Southampton to London Pipeline Project

Responses to Written Representations -
Local Authorities

Application Document: 8.23

December 2019

Sheet 1

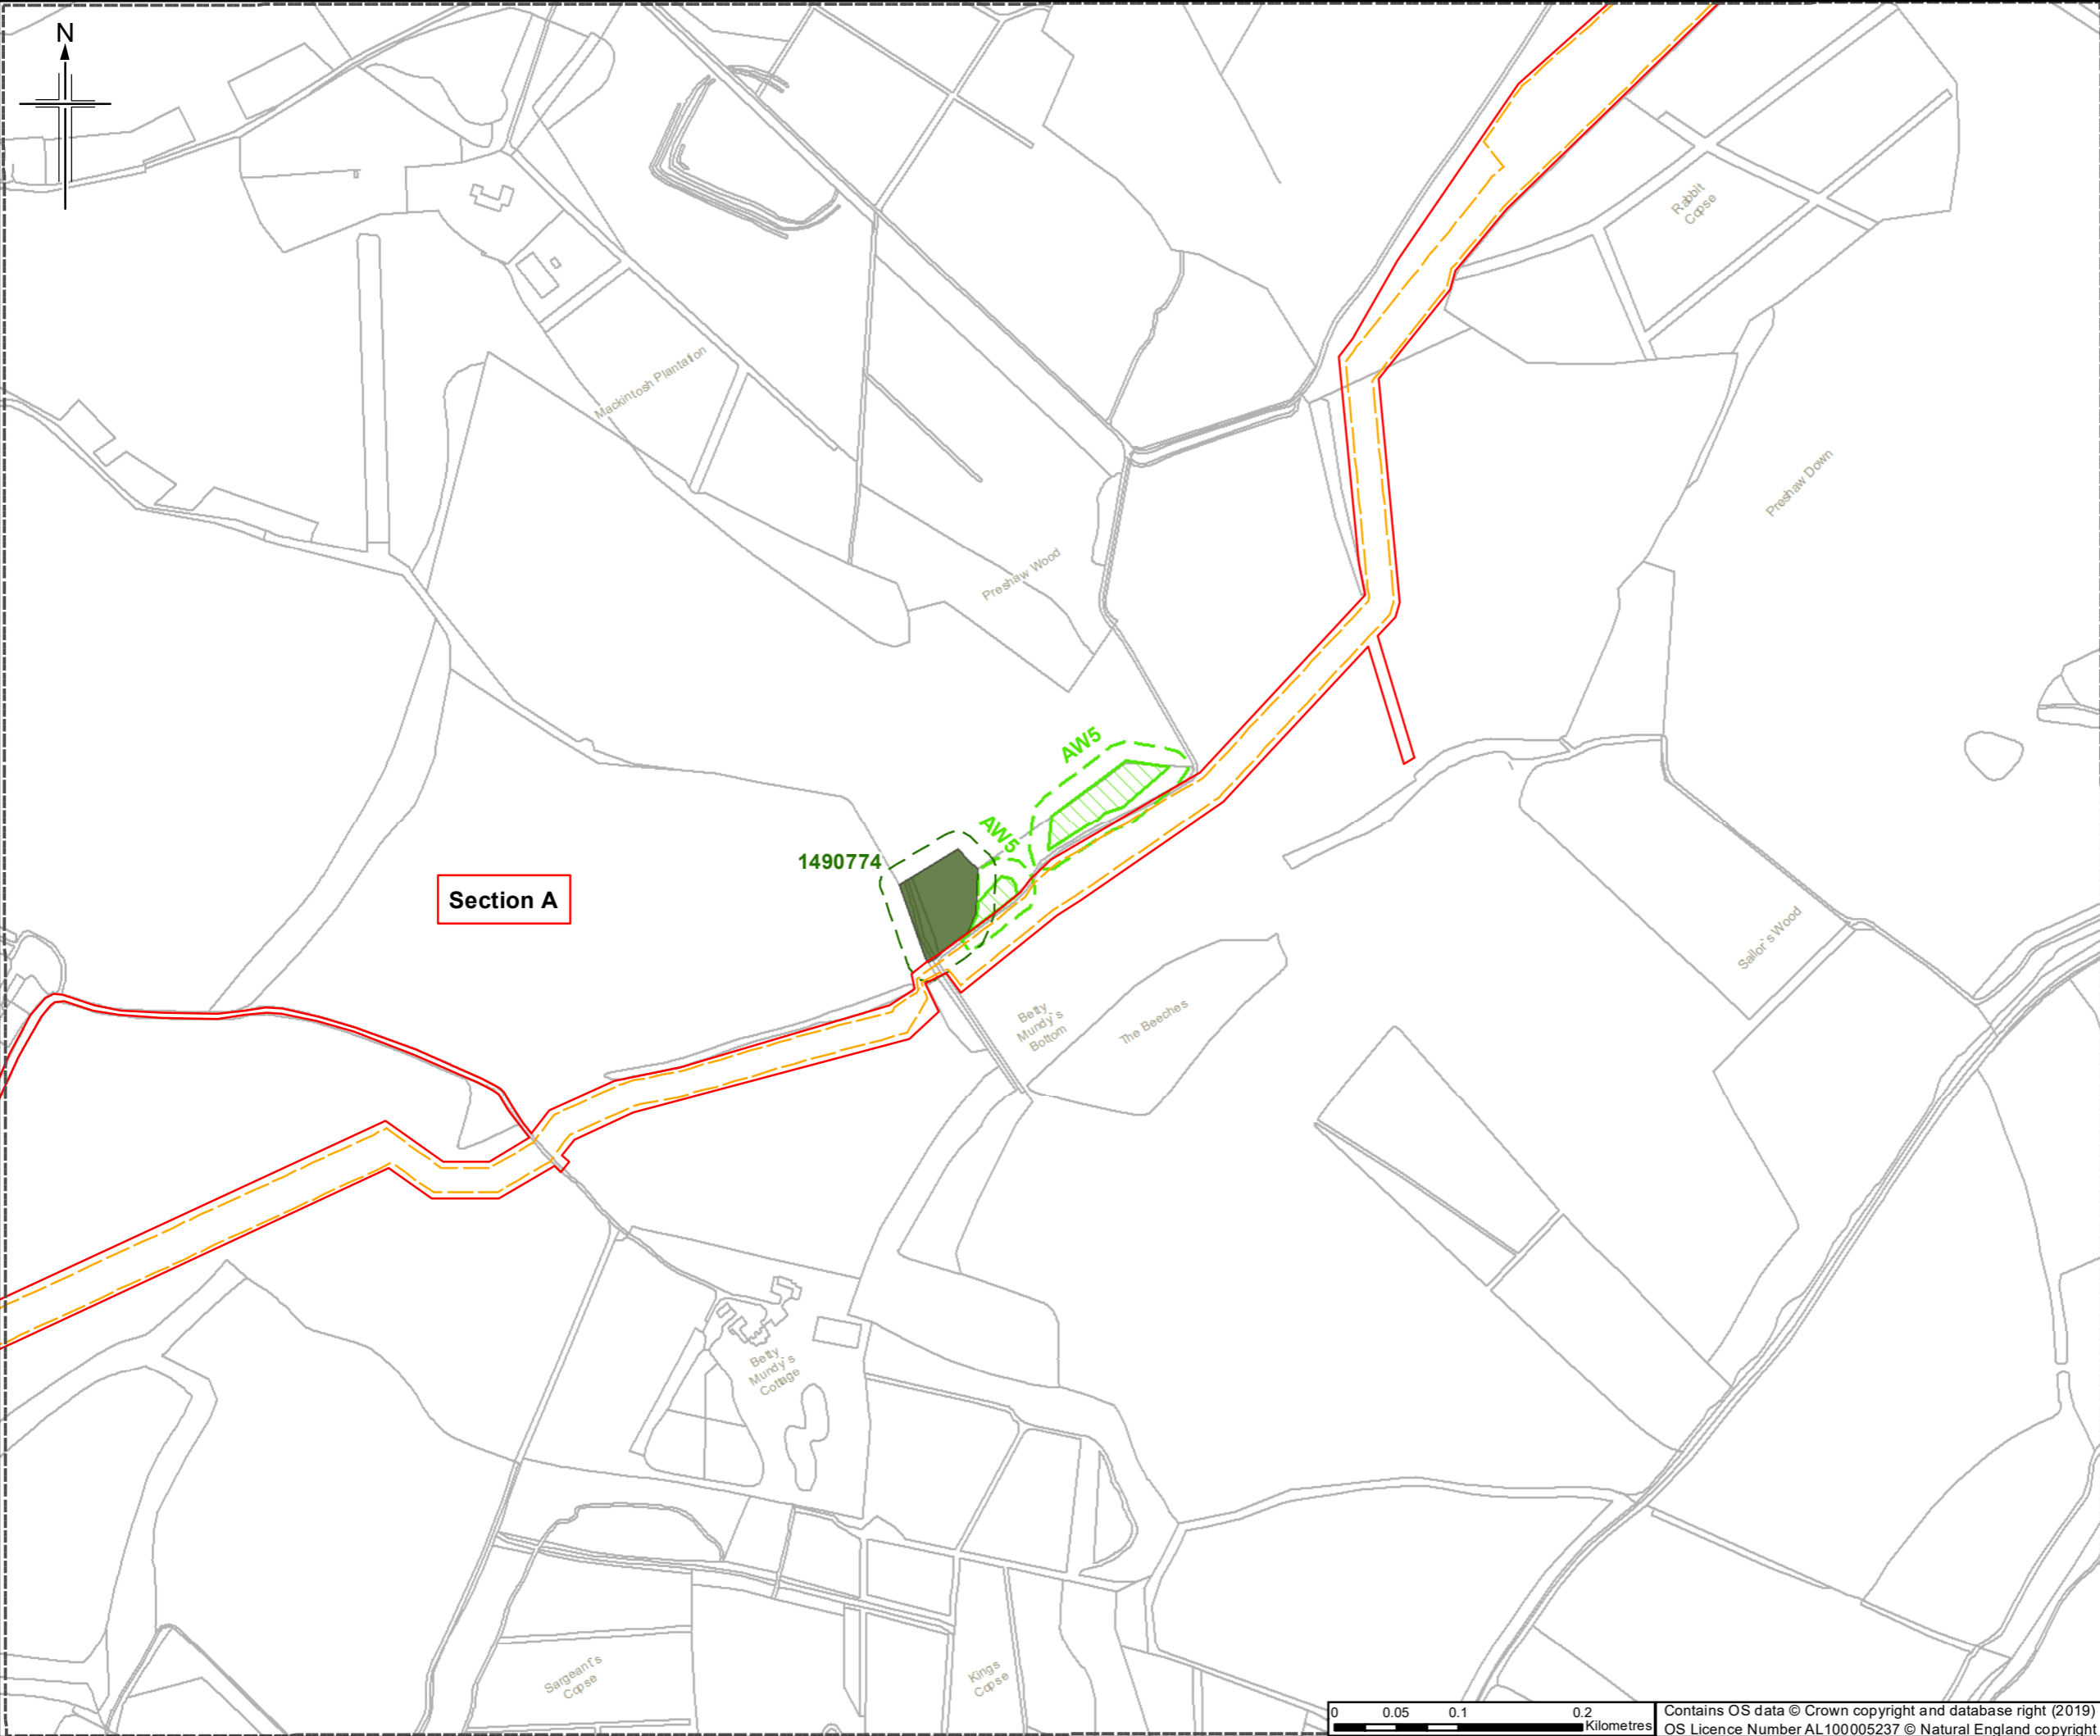
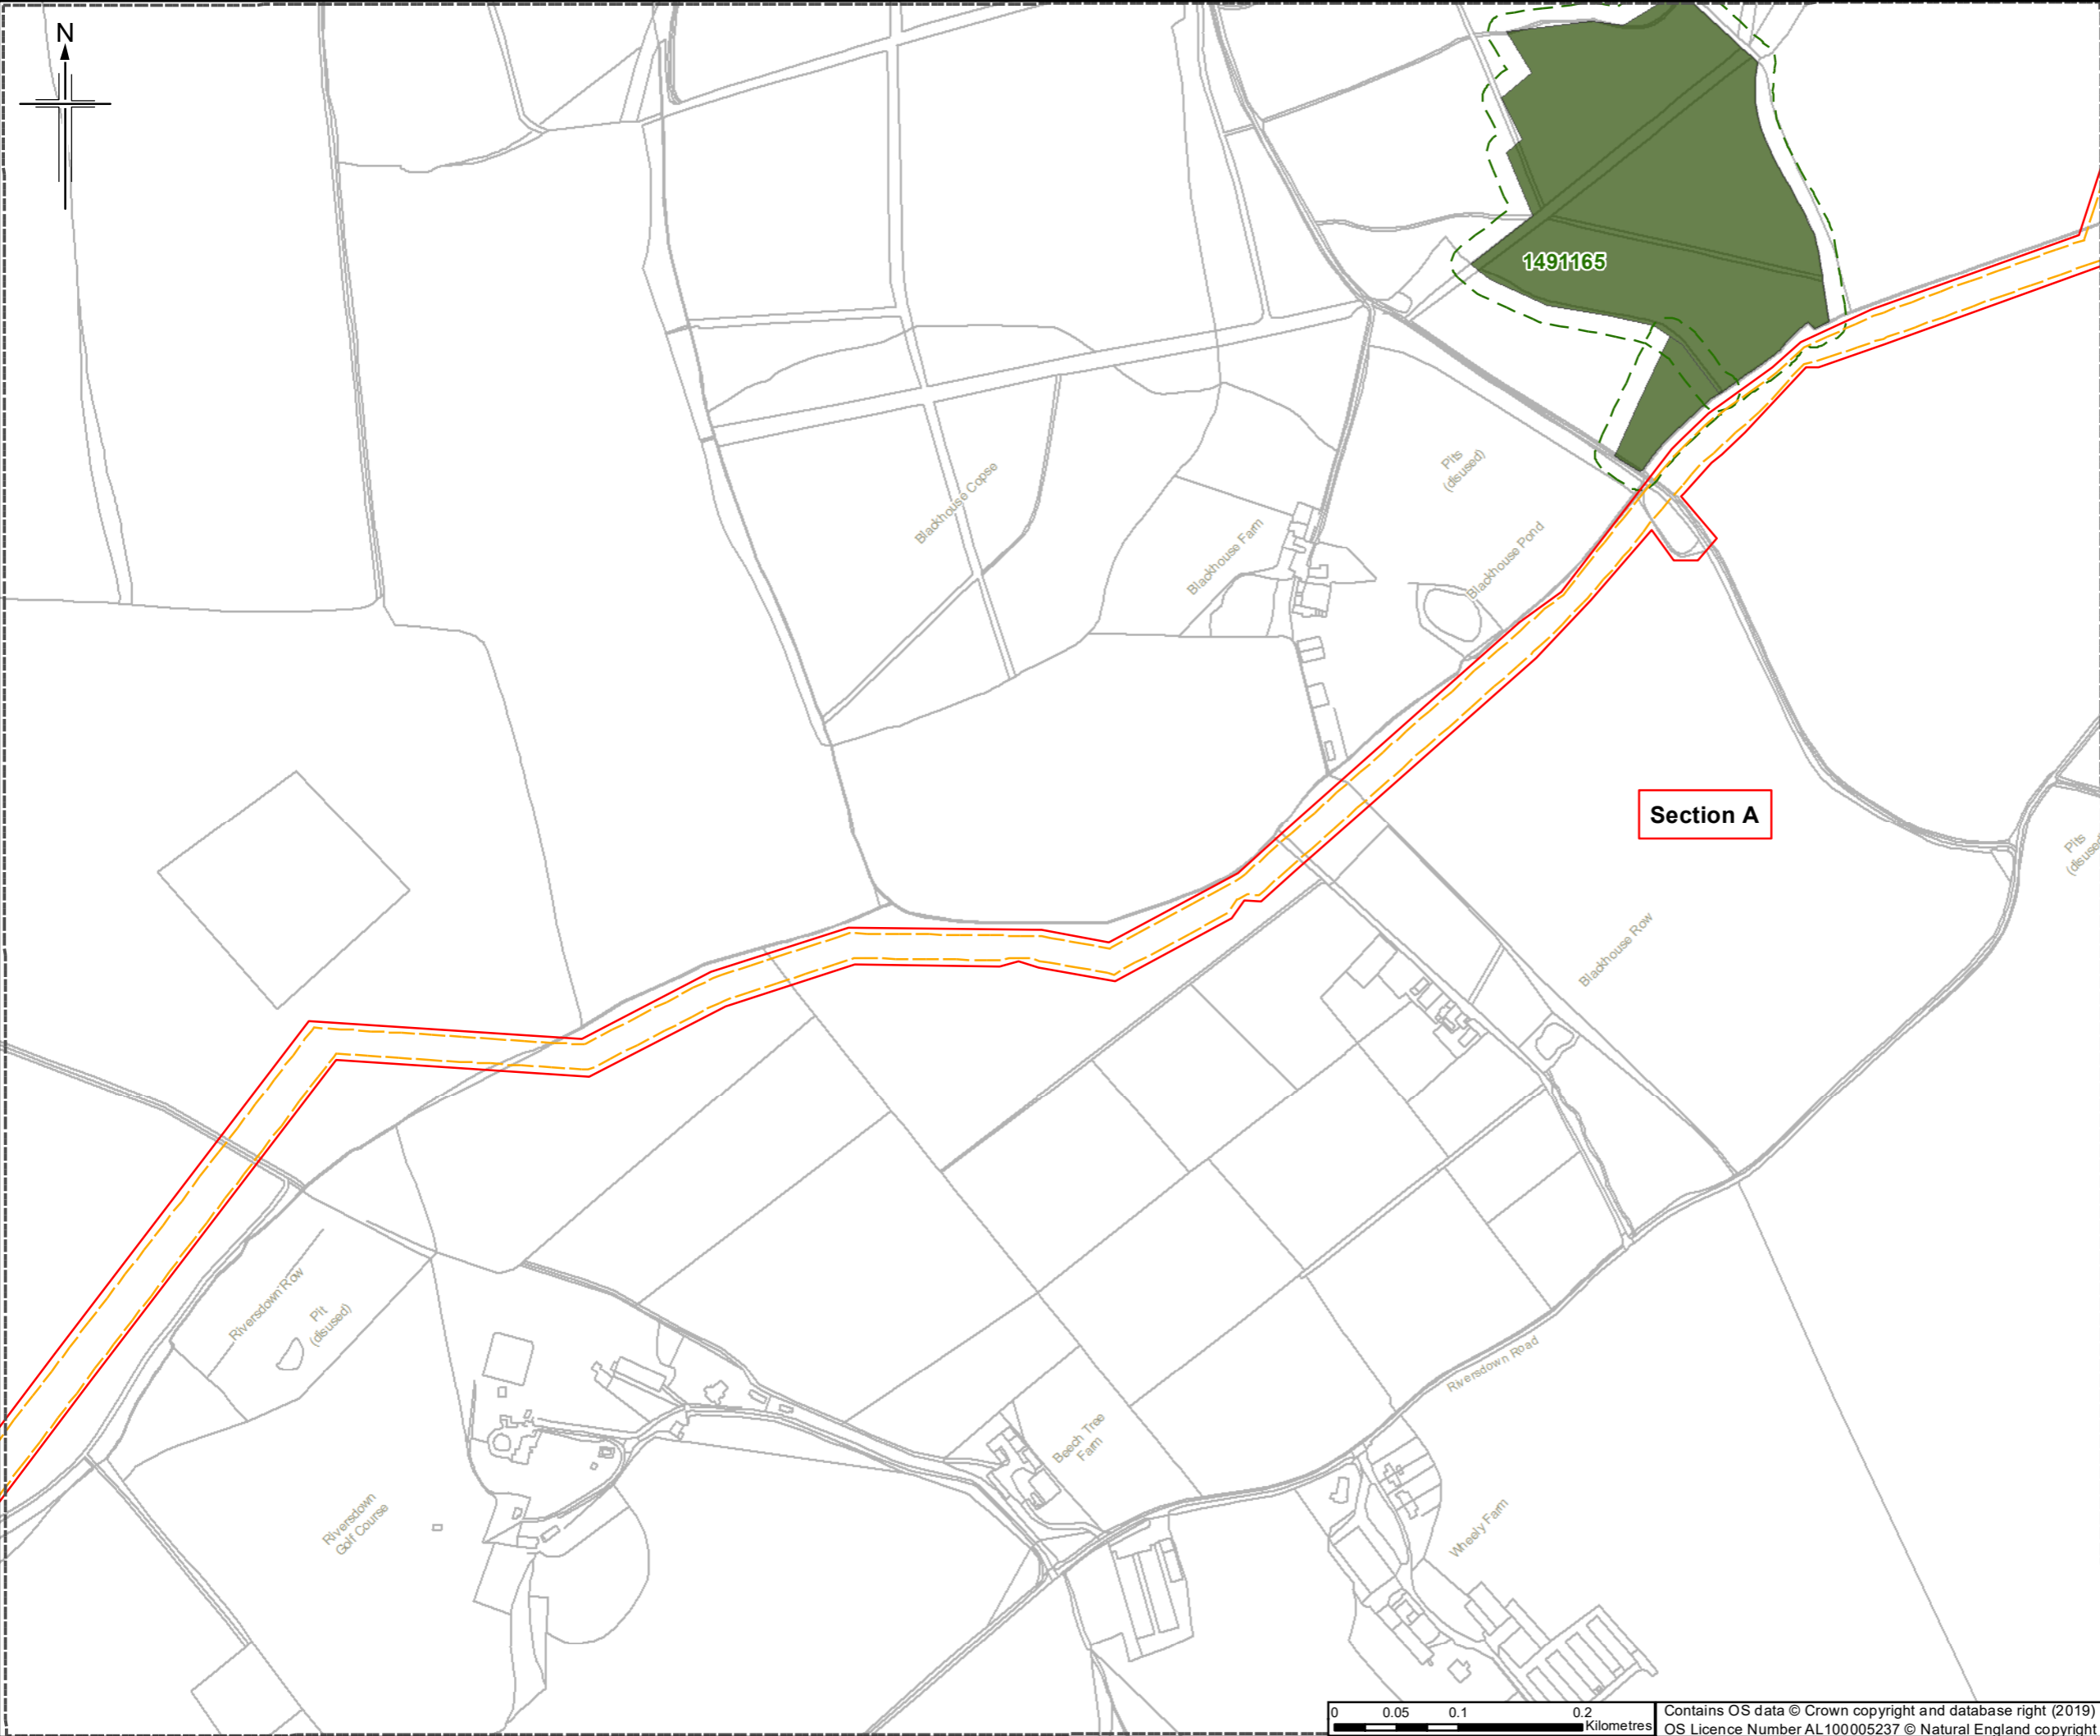
WR Para Ref	Point raised	Applicant response to point raised:
		<ul style="list-style-type: none"> reinstatement hedgerow planting would be relatively quick to establish; reinstatement tree planting would take a little longer to establish, but would have reached approximately 7m in height after 15 years. <p>It is therefore considered that, by year 15, there would be little noticeable change in the landscape character of the National Park when compared to the existing condition, and the effects on the landscape would not be significant.</p>
	<p>In its response to LV.1.25, the SDNPA furthermore requests that the A31/A32 Junction, Northfield Lane (Chawton) logistics hub be added to the list of representative viewpoints set out in the LVIA.</p>	<p>Whilst the Applicant does not consider such a representative viewpoint to be necessary, this has been prepared and is provided at Appendix 1.</p>
<p>Para 3.19 to 3.33</p>	<p>Trees and Woodland</p> <p>The SDNPA sets out concerns regarding potential impacts on, and the applicant's approach to veteran trees and ancient woodland.</p> <p>The SDNPA has requested a plan to identify which of the mitigation hierarchy measures apply to which ancient woodland.</p>	<p>The Applicant has prepared a Technical Note on Ancient Woodland and Veteran Trees (REP2-061) which sets out the approach to reduce the impacts of the project on Ancient Woodland and potential ancient woodland and Veteran Trees and potential veteran trees within 15m of the Order Limits.</p> <p>The Technical Note sets out a hierarchy of mitigation principles, ranging from the use of buffers and ground protection around trees, to the requirement for specialist construction techniques to be used for any unavoidable excavation within root protection areas. The Technical Note has regard to the joint standing advice from the Forestry Commission and Natural England (Ancient woodland, ancient trees and veteran trees: protecting them from development, 2018) when developing the hierarchy of mitigation principles, with avoidance of works within 15m of the edge of ancient woodland and 15m from the stems of veteran trees recommended where practicable.</p>

WR Para Ref	Point raised	Applicant response to point raised:
		<p>Natural England has signed a SoCG with the Applicant (REP1-005), Section 3 of which sets out agreement on matters including:</p> <ul style="list-style-type: none"> • avoiding classified ancient woodland and reducing impacts on potential ancient woodland; • the mitigation proposed in Chapters 7 (Application Document APP-047) and 16 (Application Document APP-056) of the ES; and • working methods in relation to ancient woodland and veteran trees. <p>The Forestry Commission has signed an SoCG with the Applicant (REP2-025), Section 3 of which sets out agreement on matters including:</p> <ul style="list-style-type: none"> • that the proposed approach to mitigating effects on Ancient Woodland, potential ancient woodland and veteran trees, as described in the ES (Application Document APP-056) and the further information included in the Ancient Woodland and Veteran Trees Technical Note (REP2-061) are appropriate; • that appropriate measures have been taken to identify all areas of Ancient Woodland, and areas of Potential Ancient Woodland that do not appear on Natural England's Ancient Woodland Inventory; and • that the Order Limits avoid all areas of existing classified Ancient Woodland. <p>In addition, the Applicant has prepared a plan showing the locations of Ancient Woodland, potential ancient woodland, Veteran Trees and potential veteran trees (see Figure 1 and 2 appended to this document).</p>
